CONDOMINIUM SITE PLAN OCEAN ROAD CONDOS

TAX MAP 292, LOTS 151-1, 151-2 & 153 65 OCEAN ROAD & 3110 LAFAYETTE ROAD PORTSMOUTH, NH 03801

RE: Response Letter – TAC Comments
3110 Lafayette Road & 65 Ocean Road, Portsmouth, NH
Tax Map 292, Lots 151-1 & 151-2
JBE Project No. 18165

CONCRETE SIDEWALK W/ VERTICAL GRANITE CURB

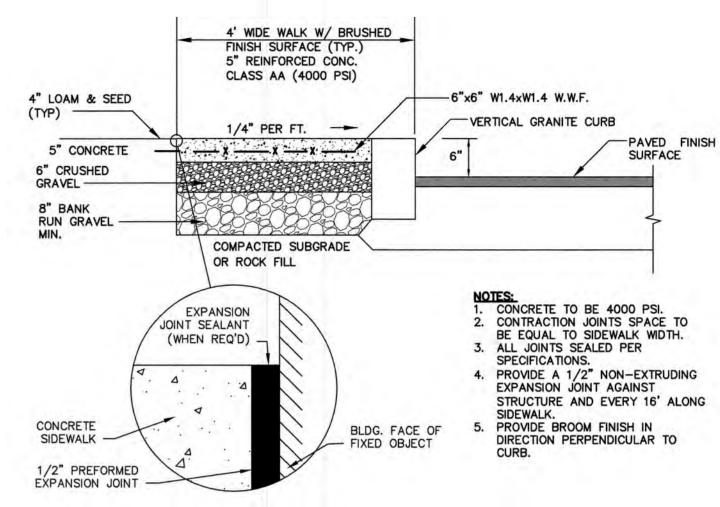
RESPONSE: See above.
- 23. Bituminous Sidewalk Due to durability and maintenance concerns, consideration should be given to using concrete for the sidewalks.

RESPONSE: Bituminous sidewalks have been replaced with concrete sidewalks.
- 24. Landscape Plan If the existing vegetative buffer is inadequate, fencing should also be considered along the property lines abutting other residential properties.

STOP SIGN (R1-1)

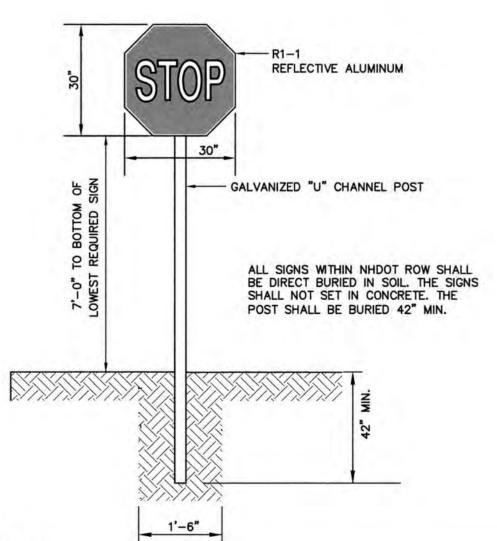
6. STOP sign should be 30"x 30", not 36".
RESPONSE: Stop sign has been changed to 30" x 30".

CATCH BASIN WITH GREASE HOOD

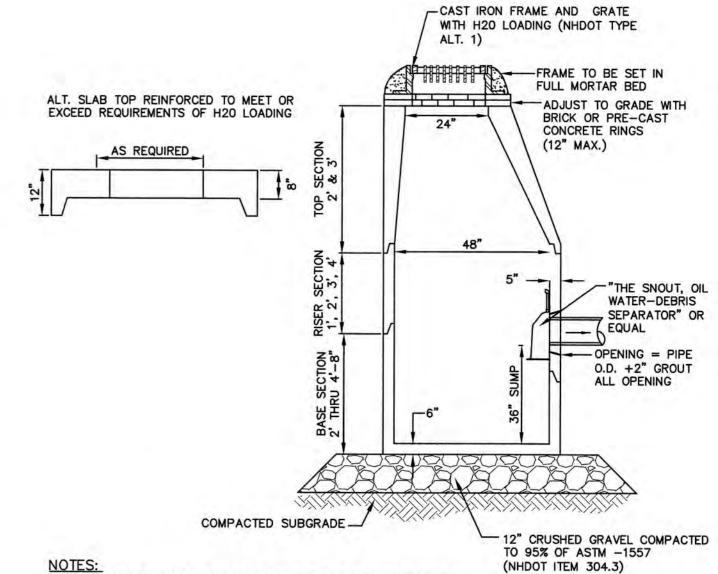
RESPONSE: The catch basins will all have sumps and grease hoods to aid in

RESPONSE: The catch basins will all have sumps and grease hoods to aid in stormwater treatment. Stormwater from paved areas will enter an infiltration system allowing further treatment. The buildings will have drip edges to catch roof runoff from half of the roofs, which will also infiltrate.

TRUCK TURNING PLAN
TAX MAP 292, LOT 151-1, 151-2 & 153 Plan Name: 3110 LAFAYETTE ROAD AND 65 OCEAN ROAD PORTSMOUTH, NH 03801 Project:

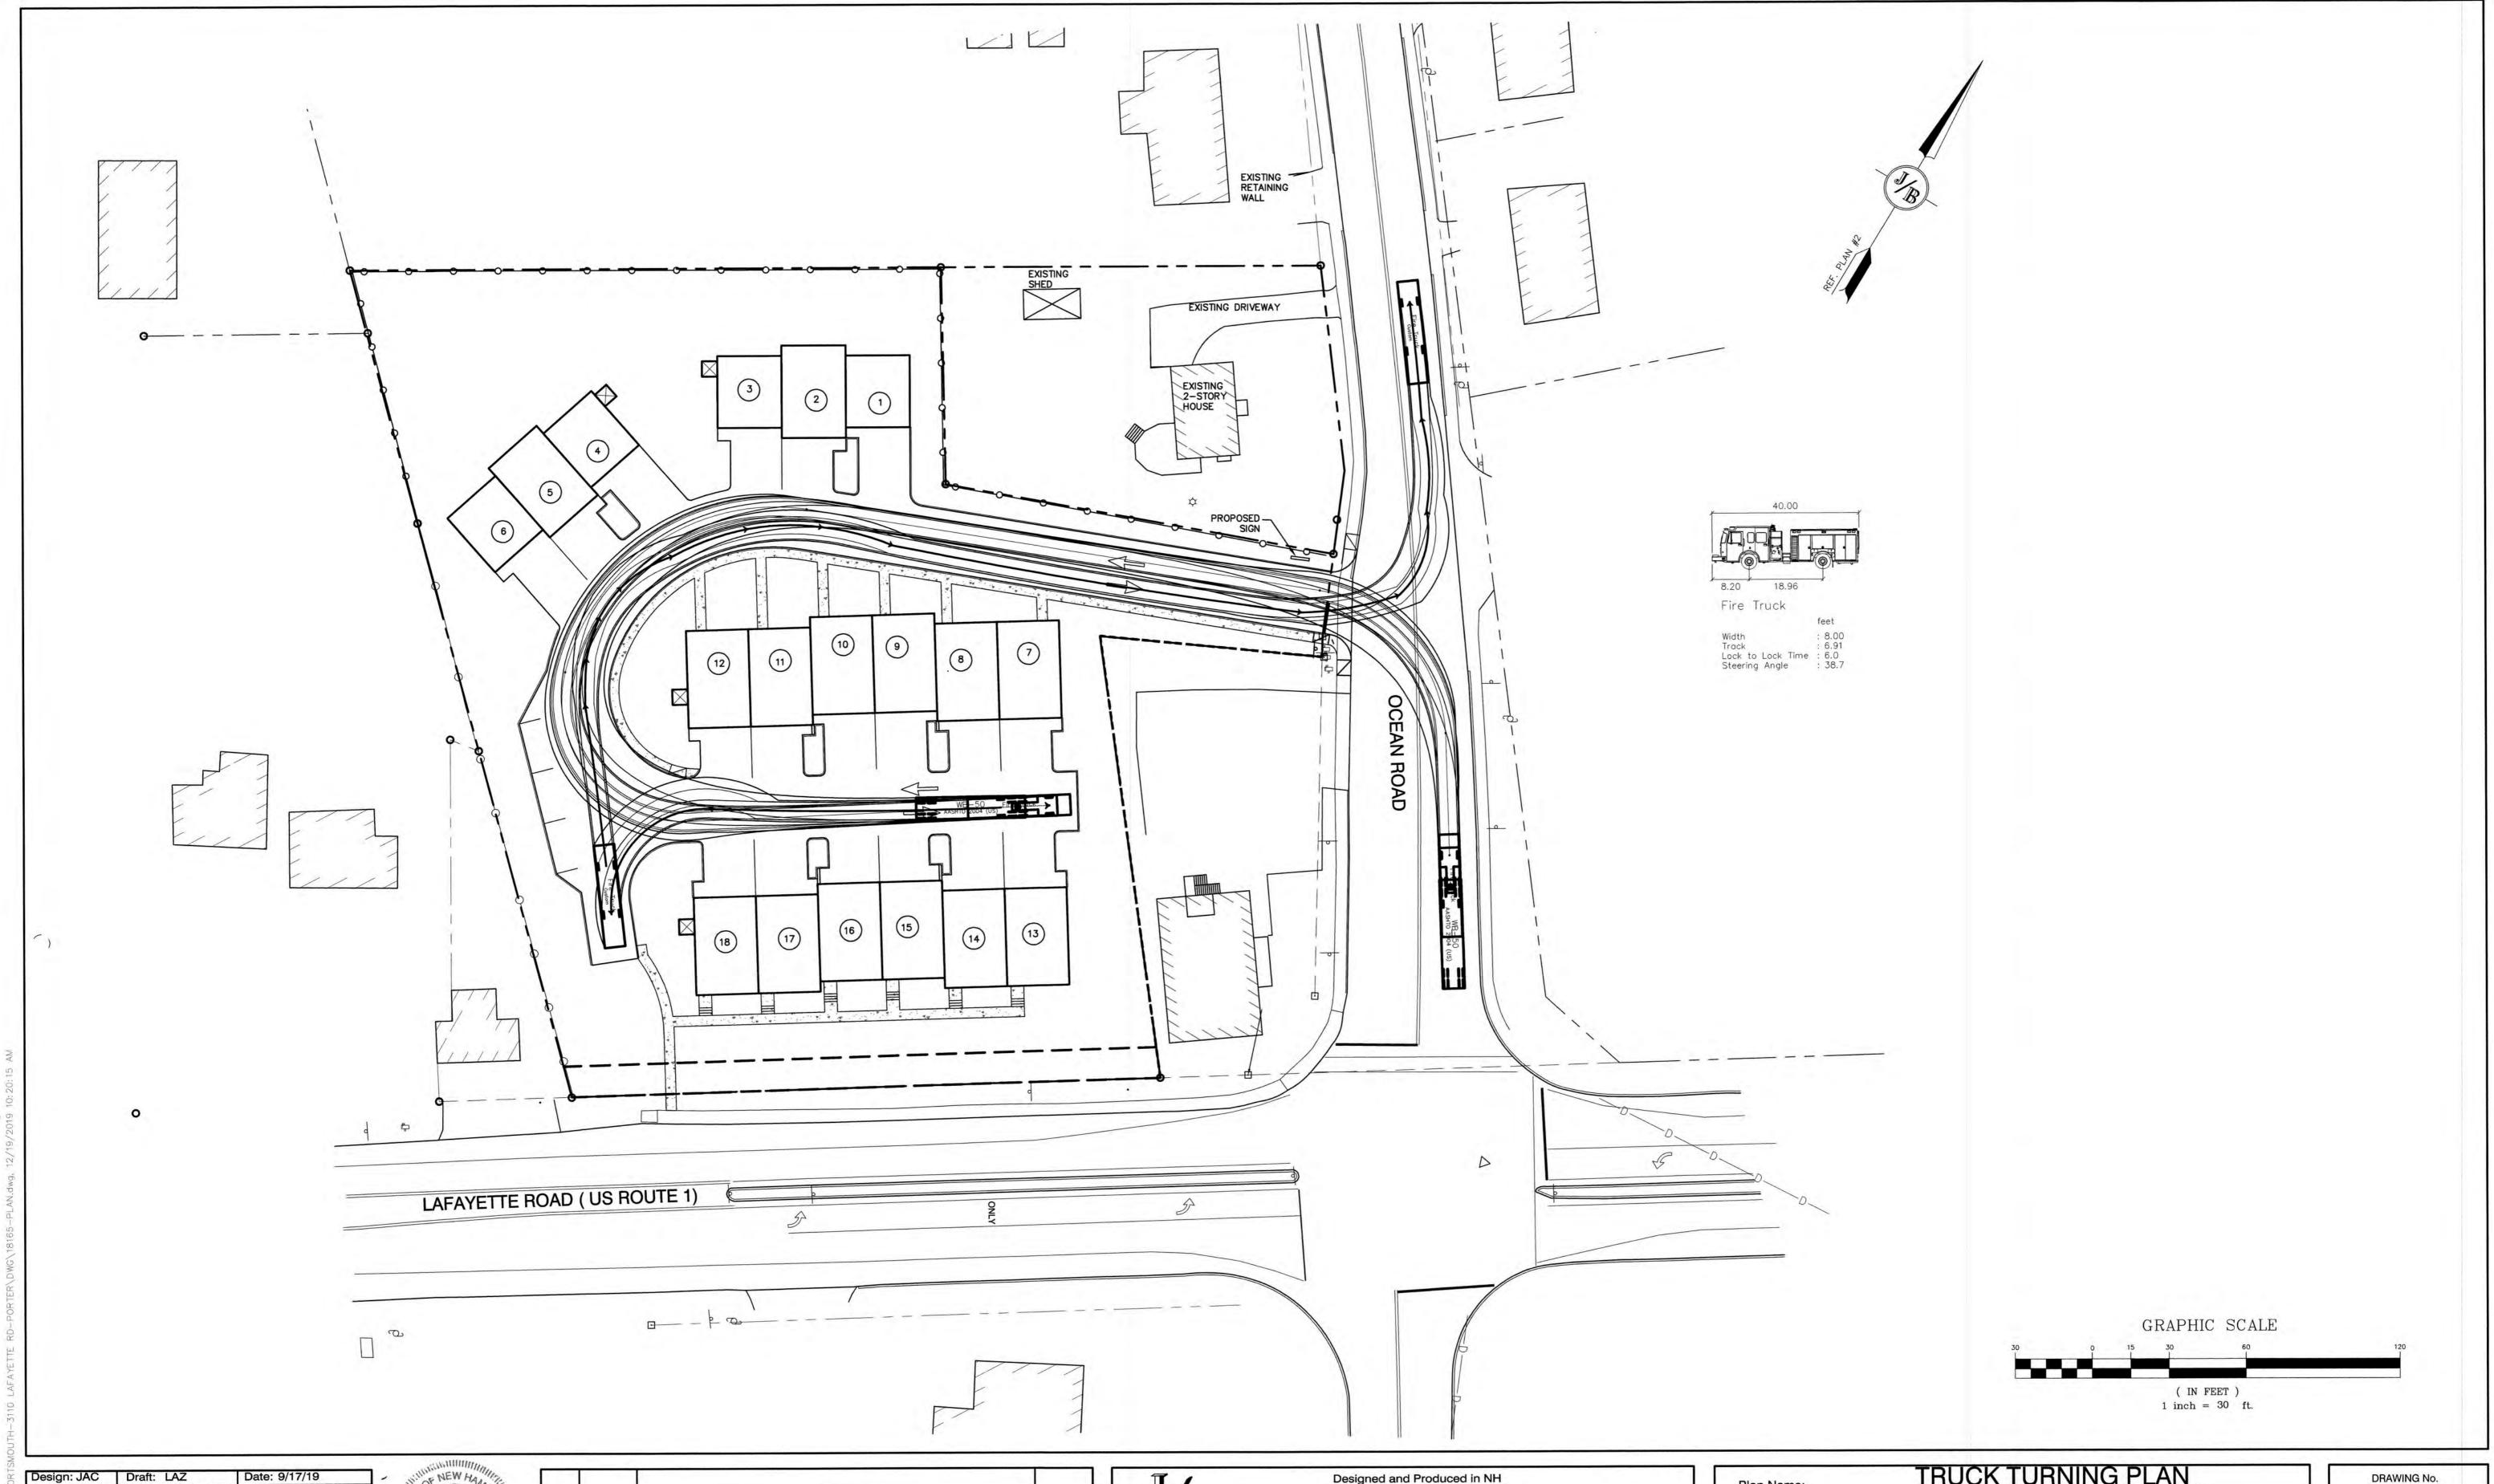
- 19. Truck Turning Plan The plan and the turning radius of WB-50 vehicle appears to show a minor conflict with any outdoor parking associated with townhouse unit #12. RESPONSE: We have revised the Truck Turning Plan to show a standard fire truck. There is no conflict with any outdoor parking with this truck.
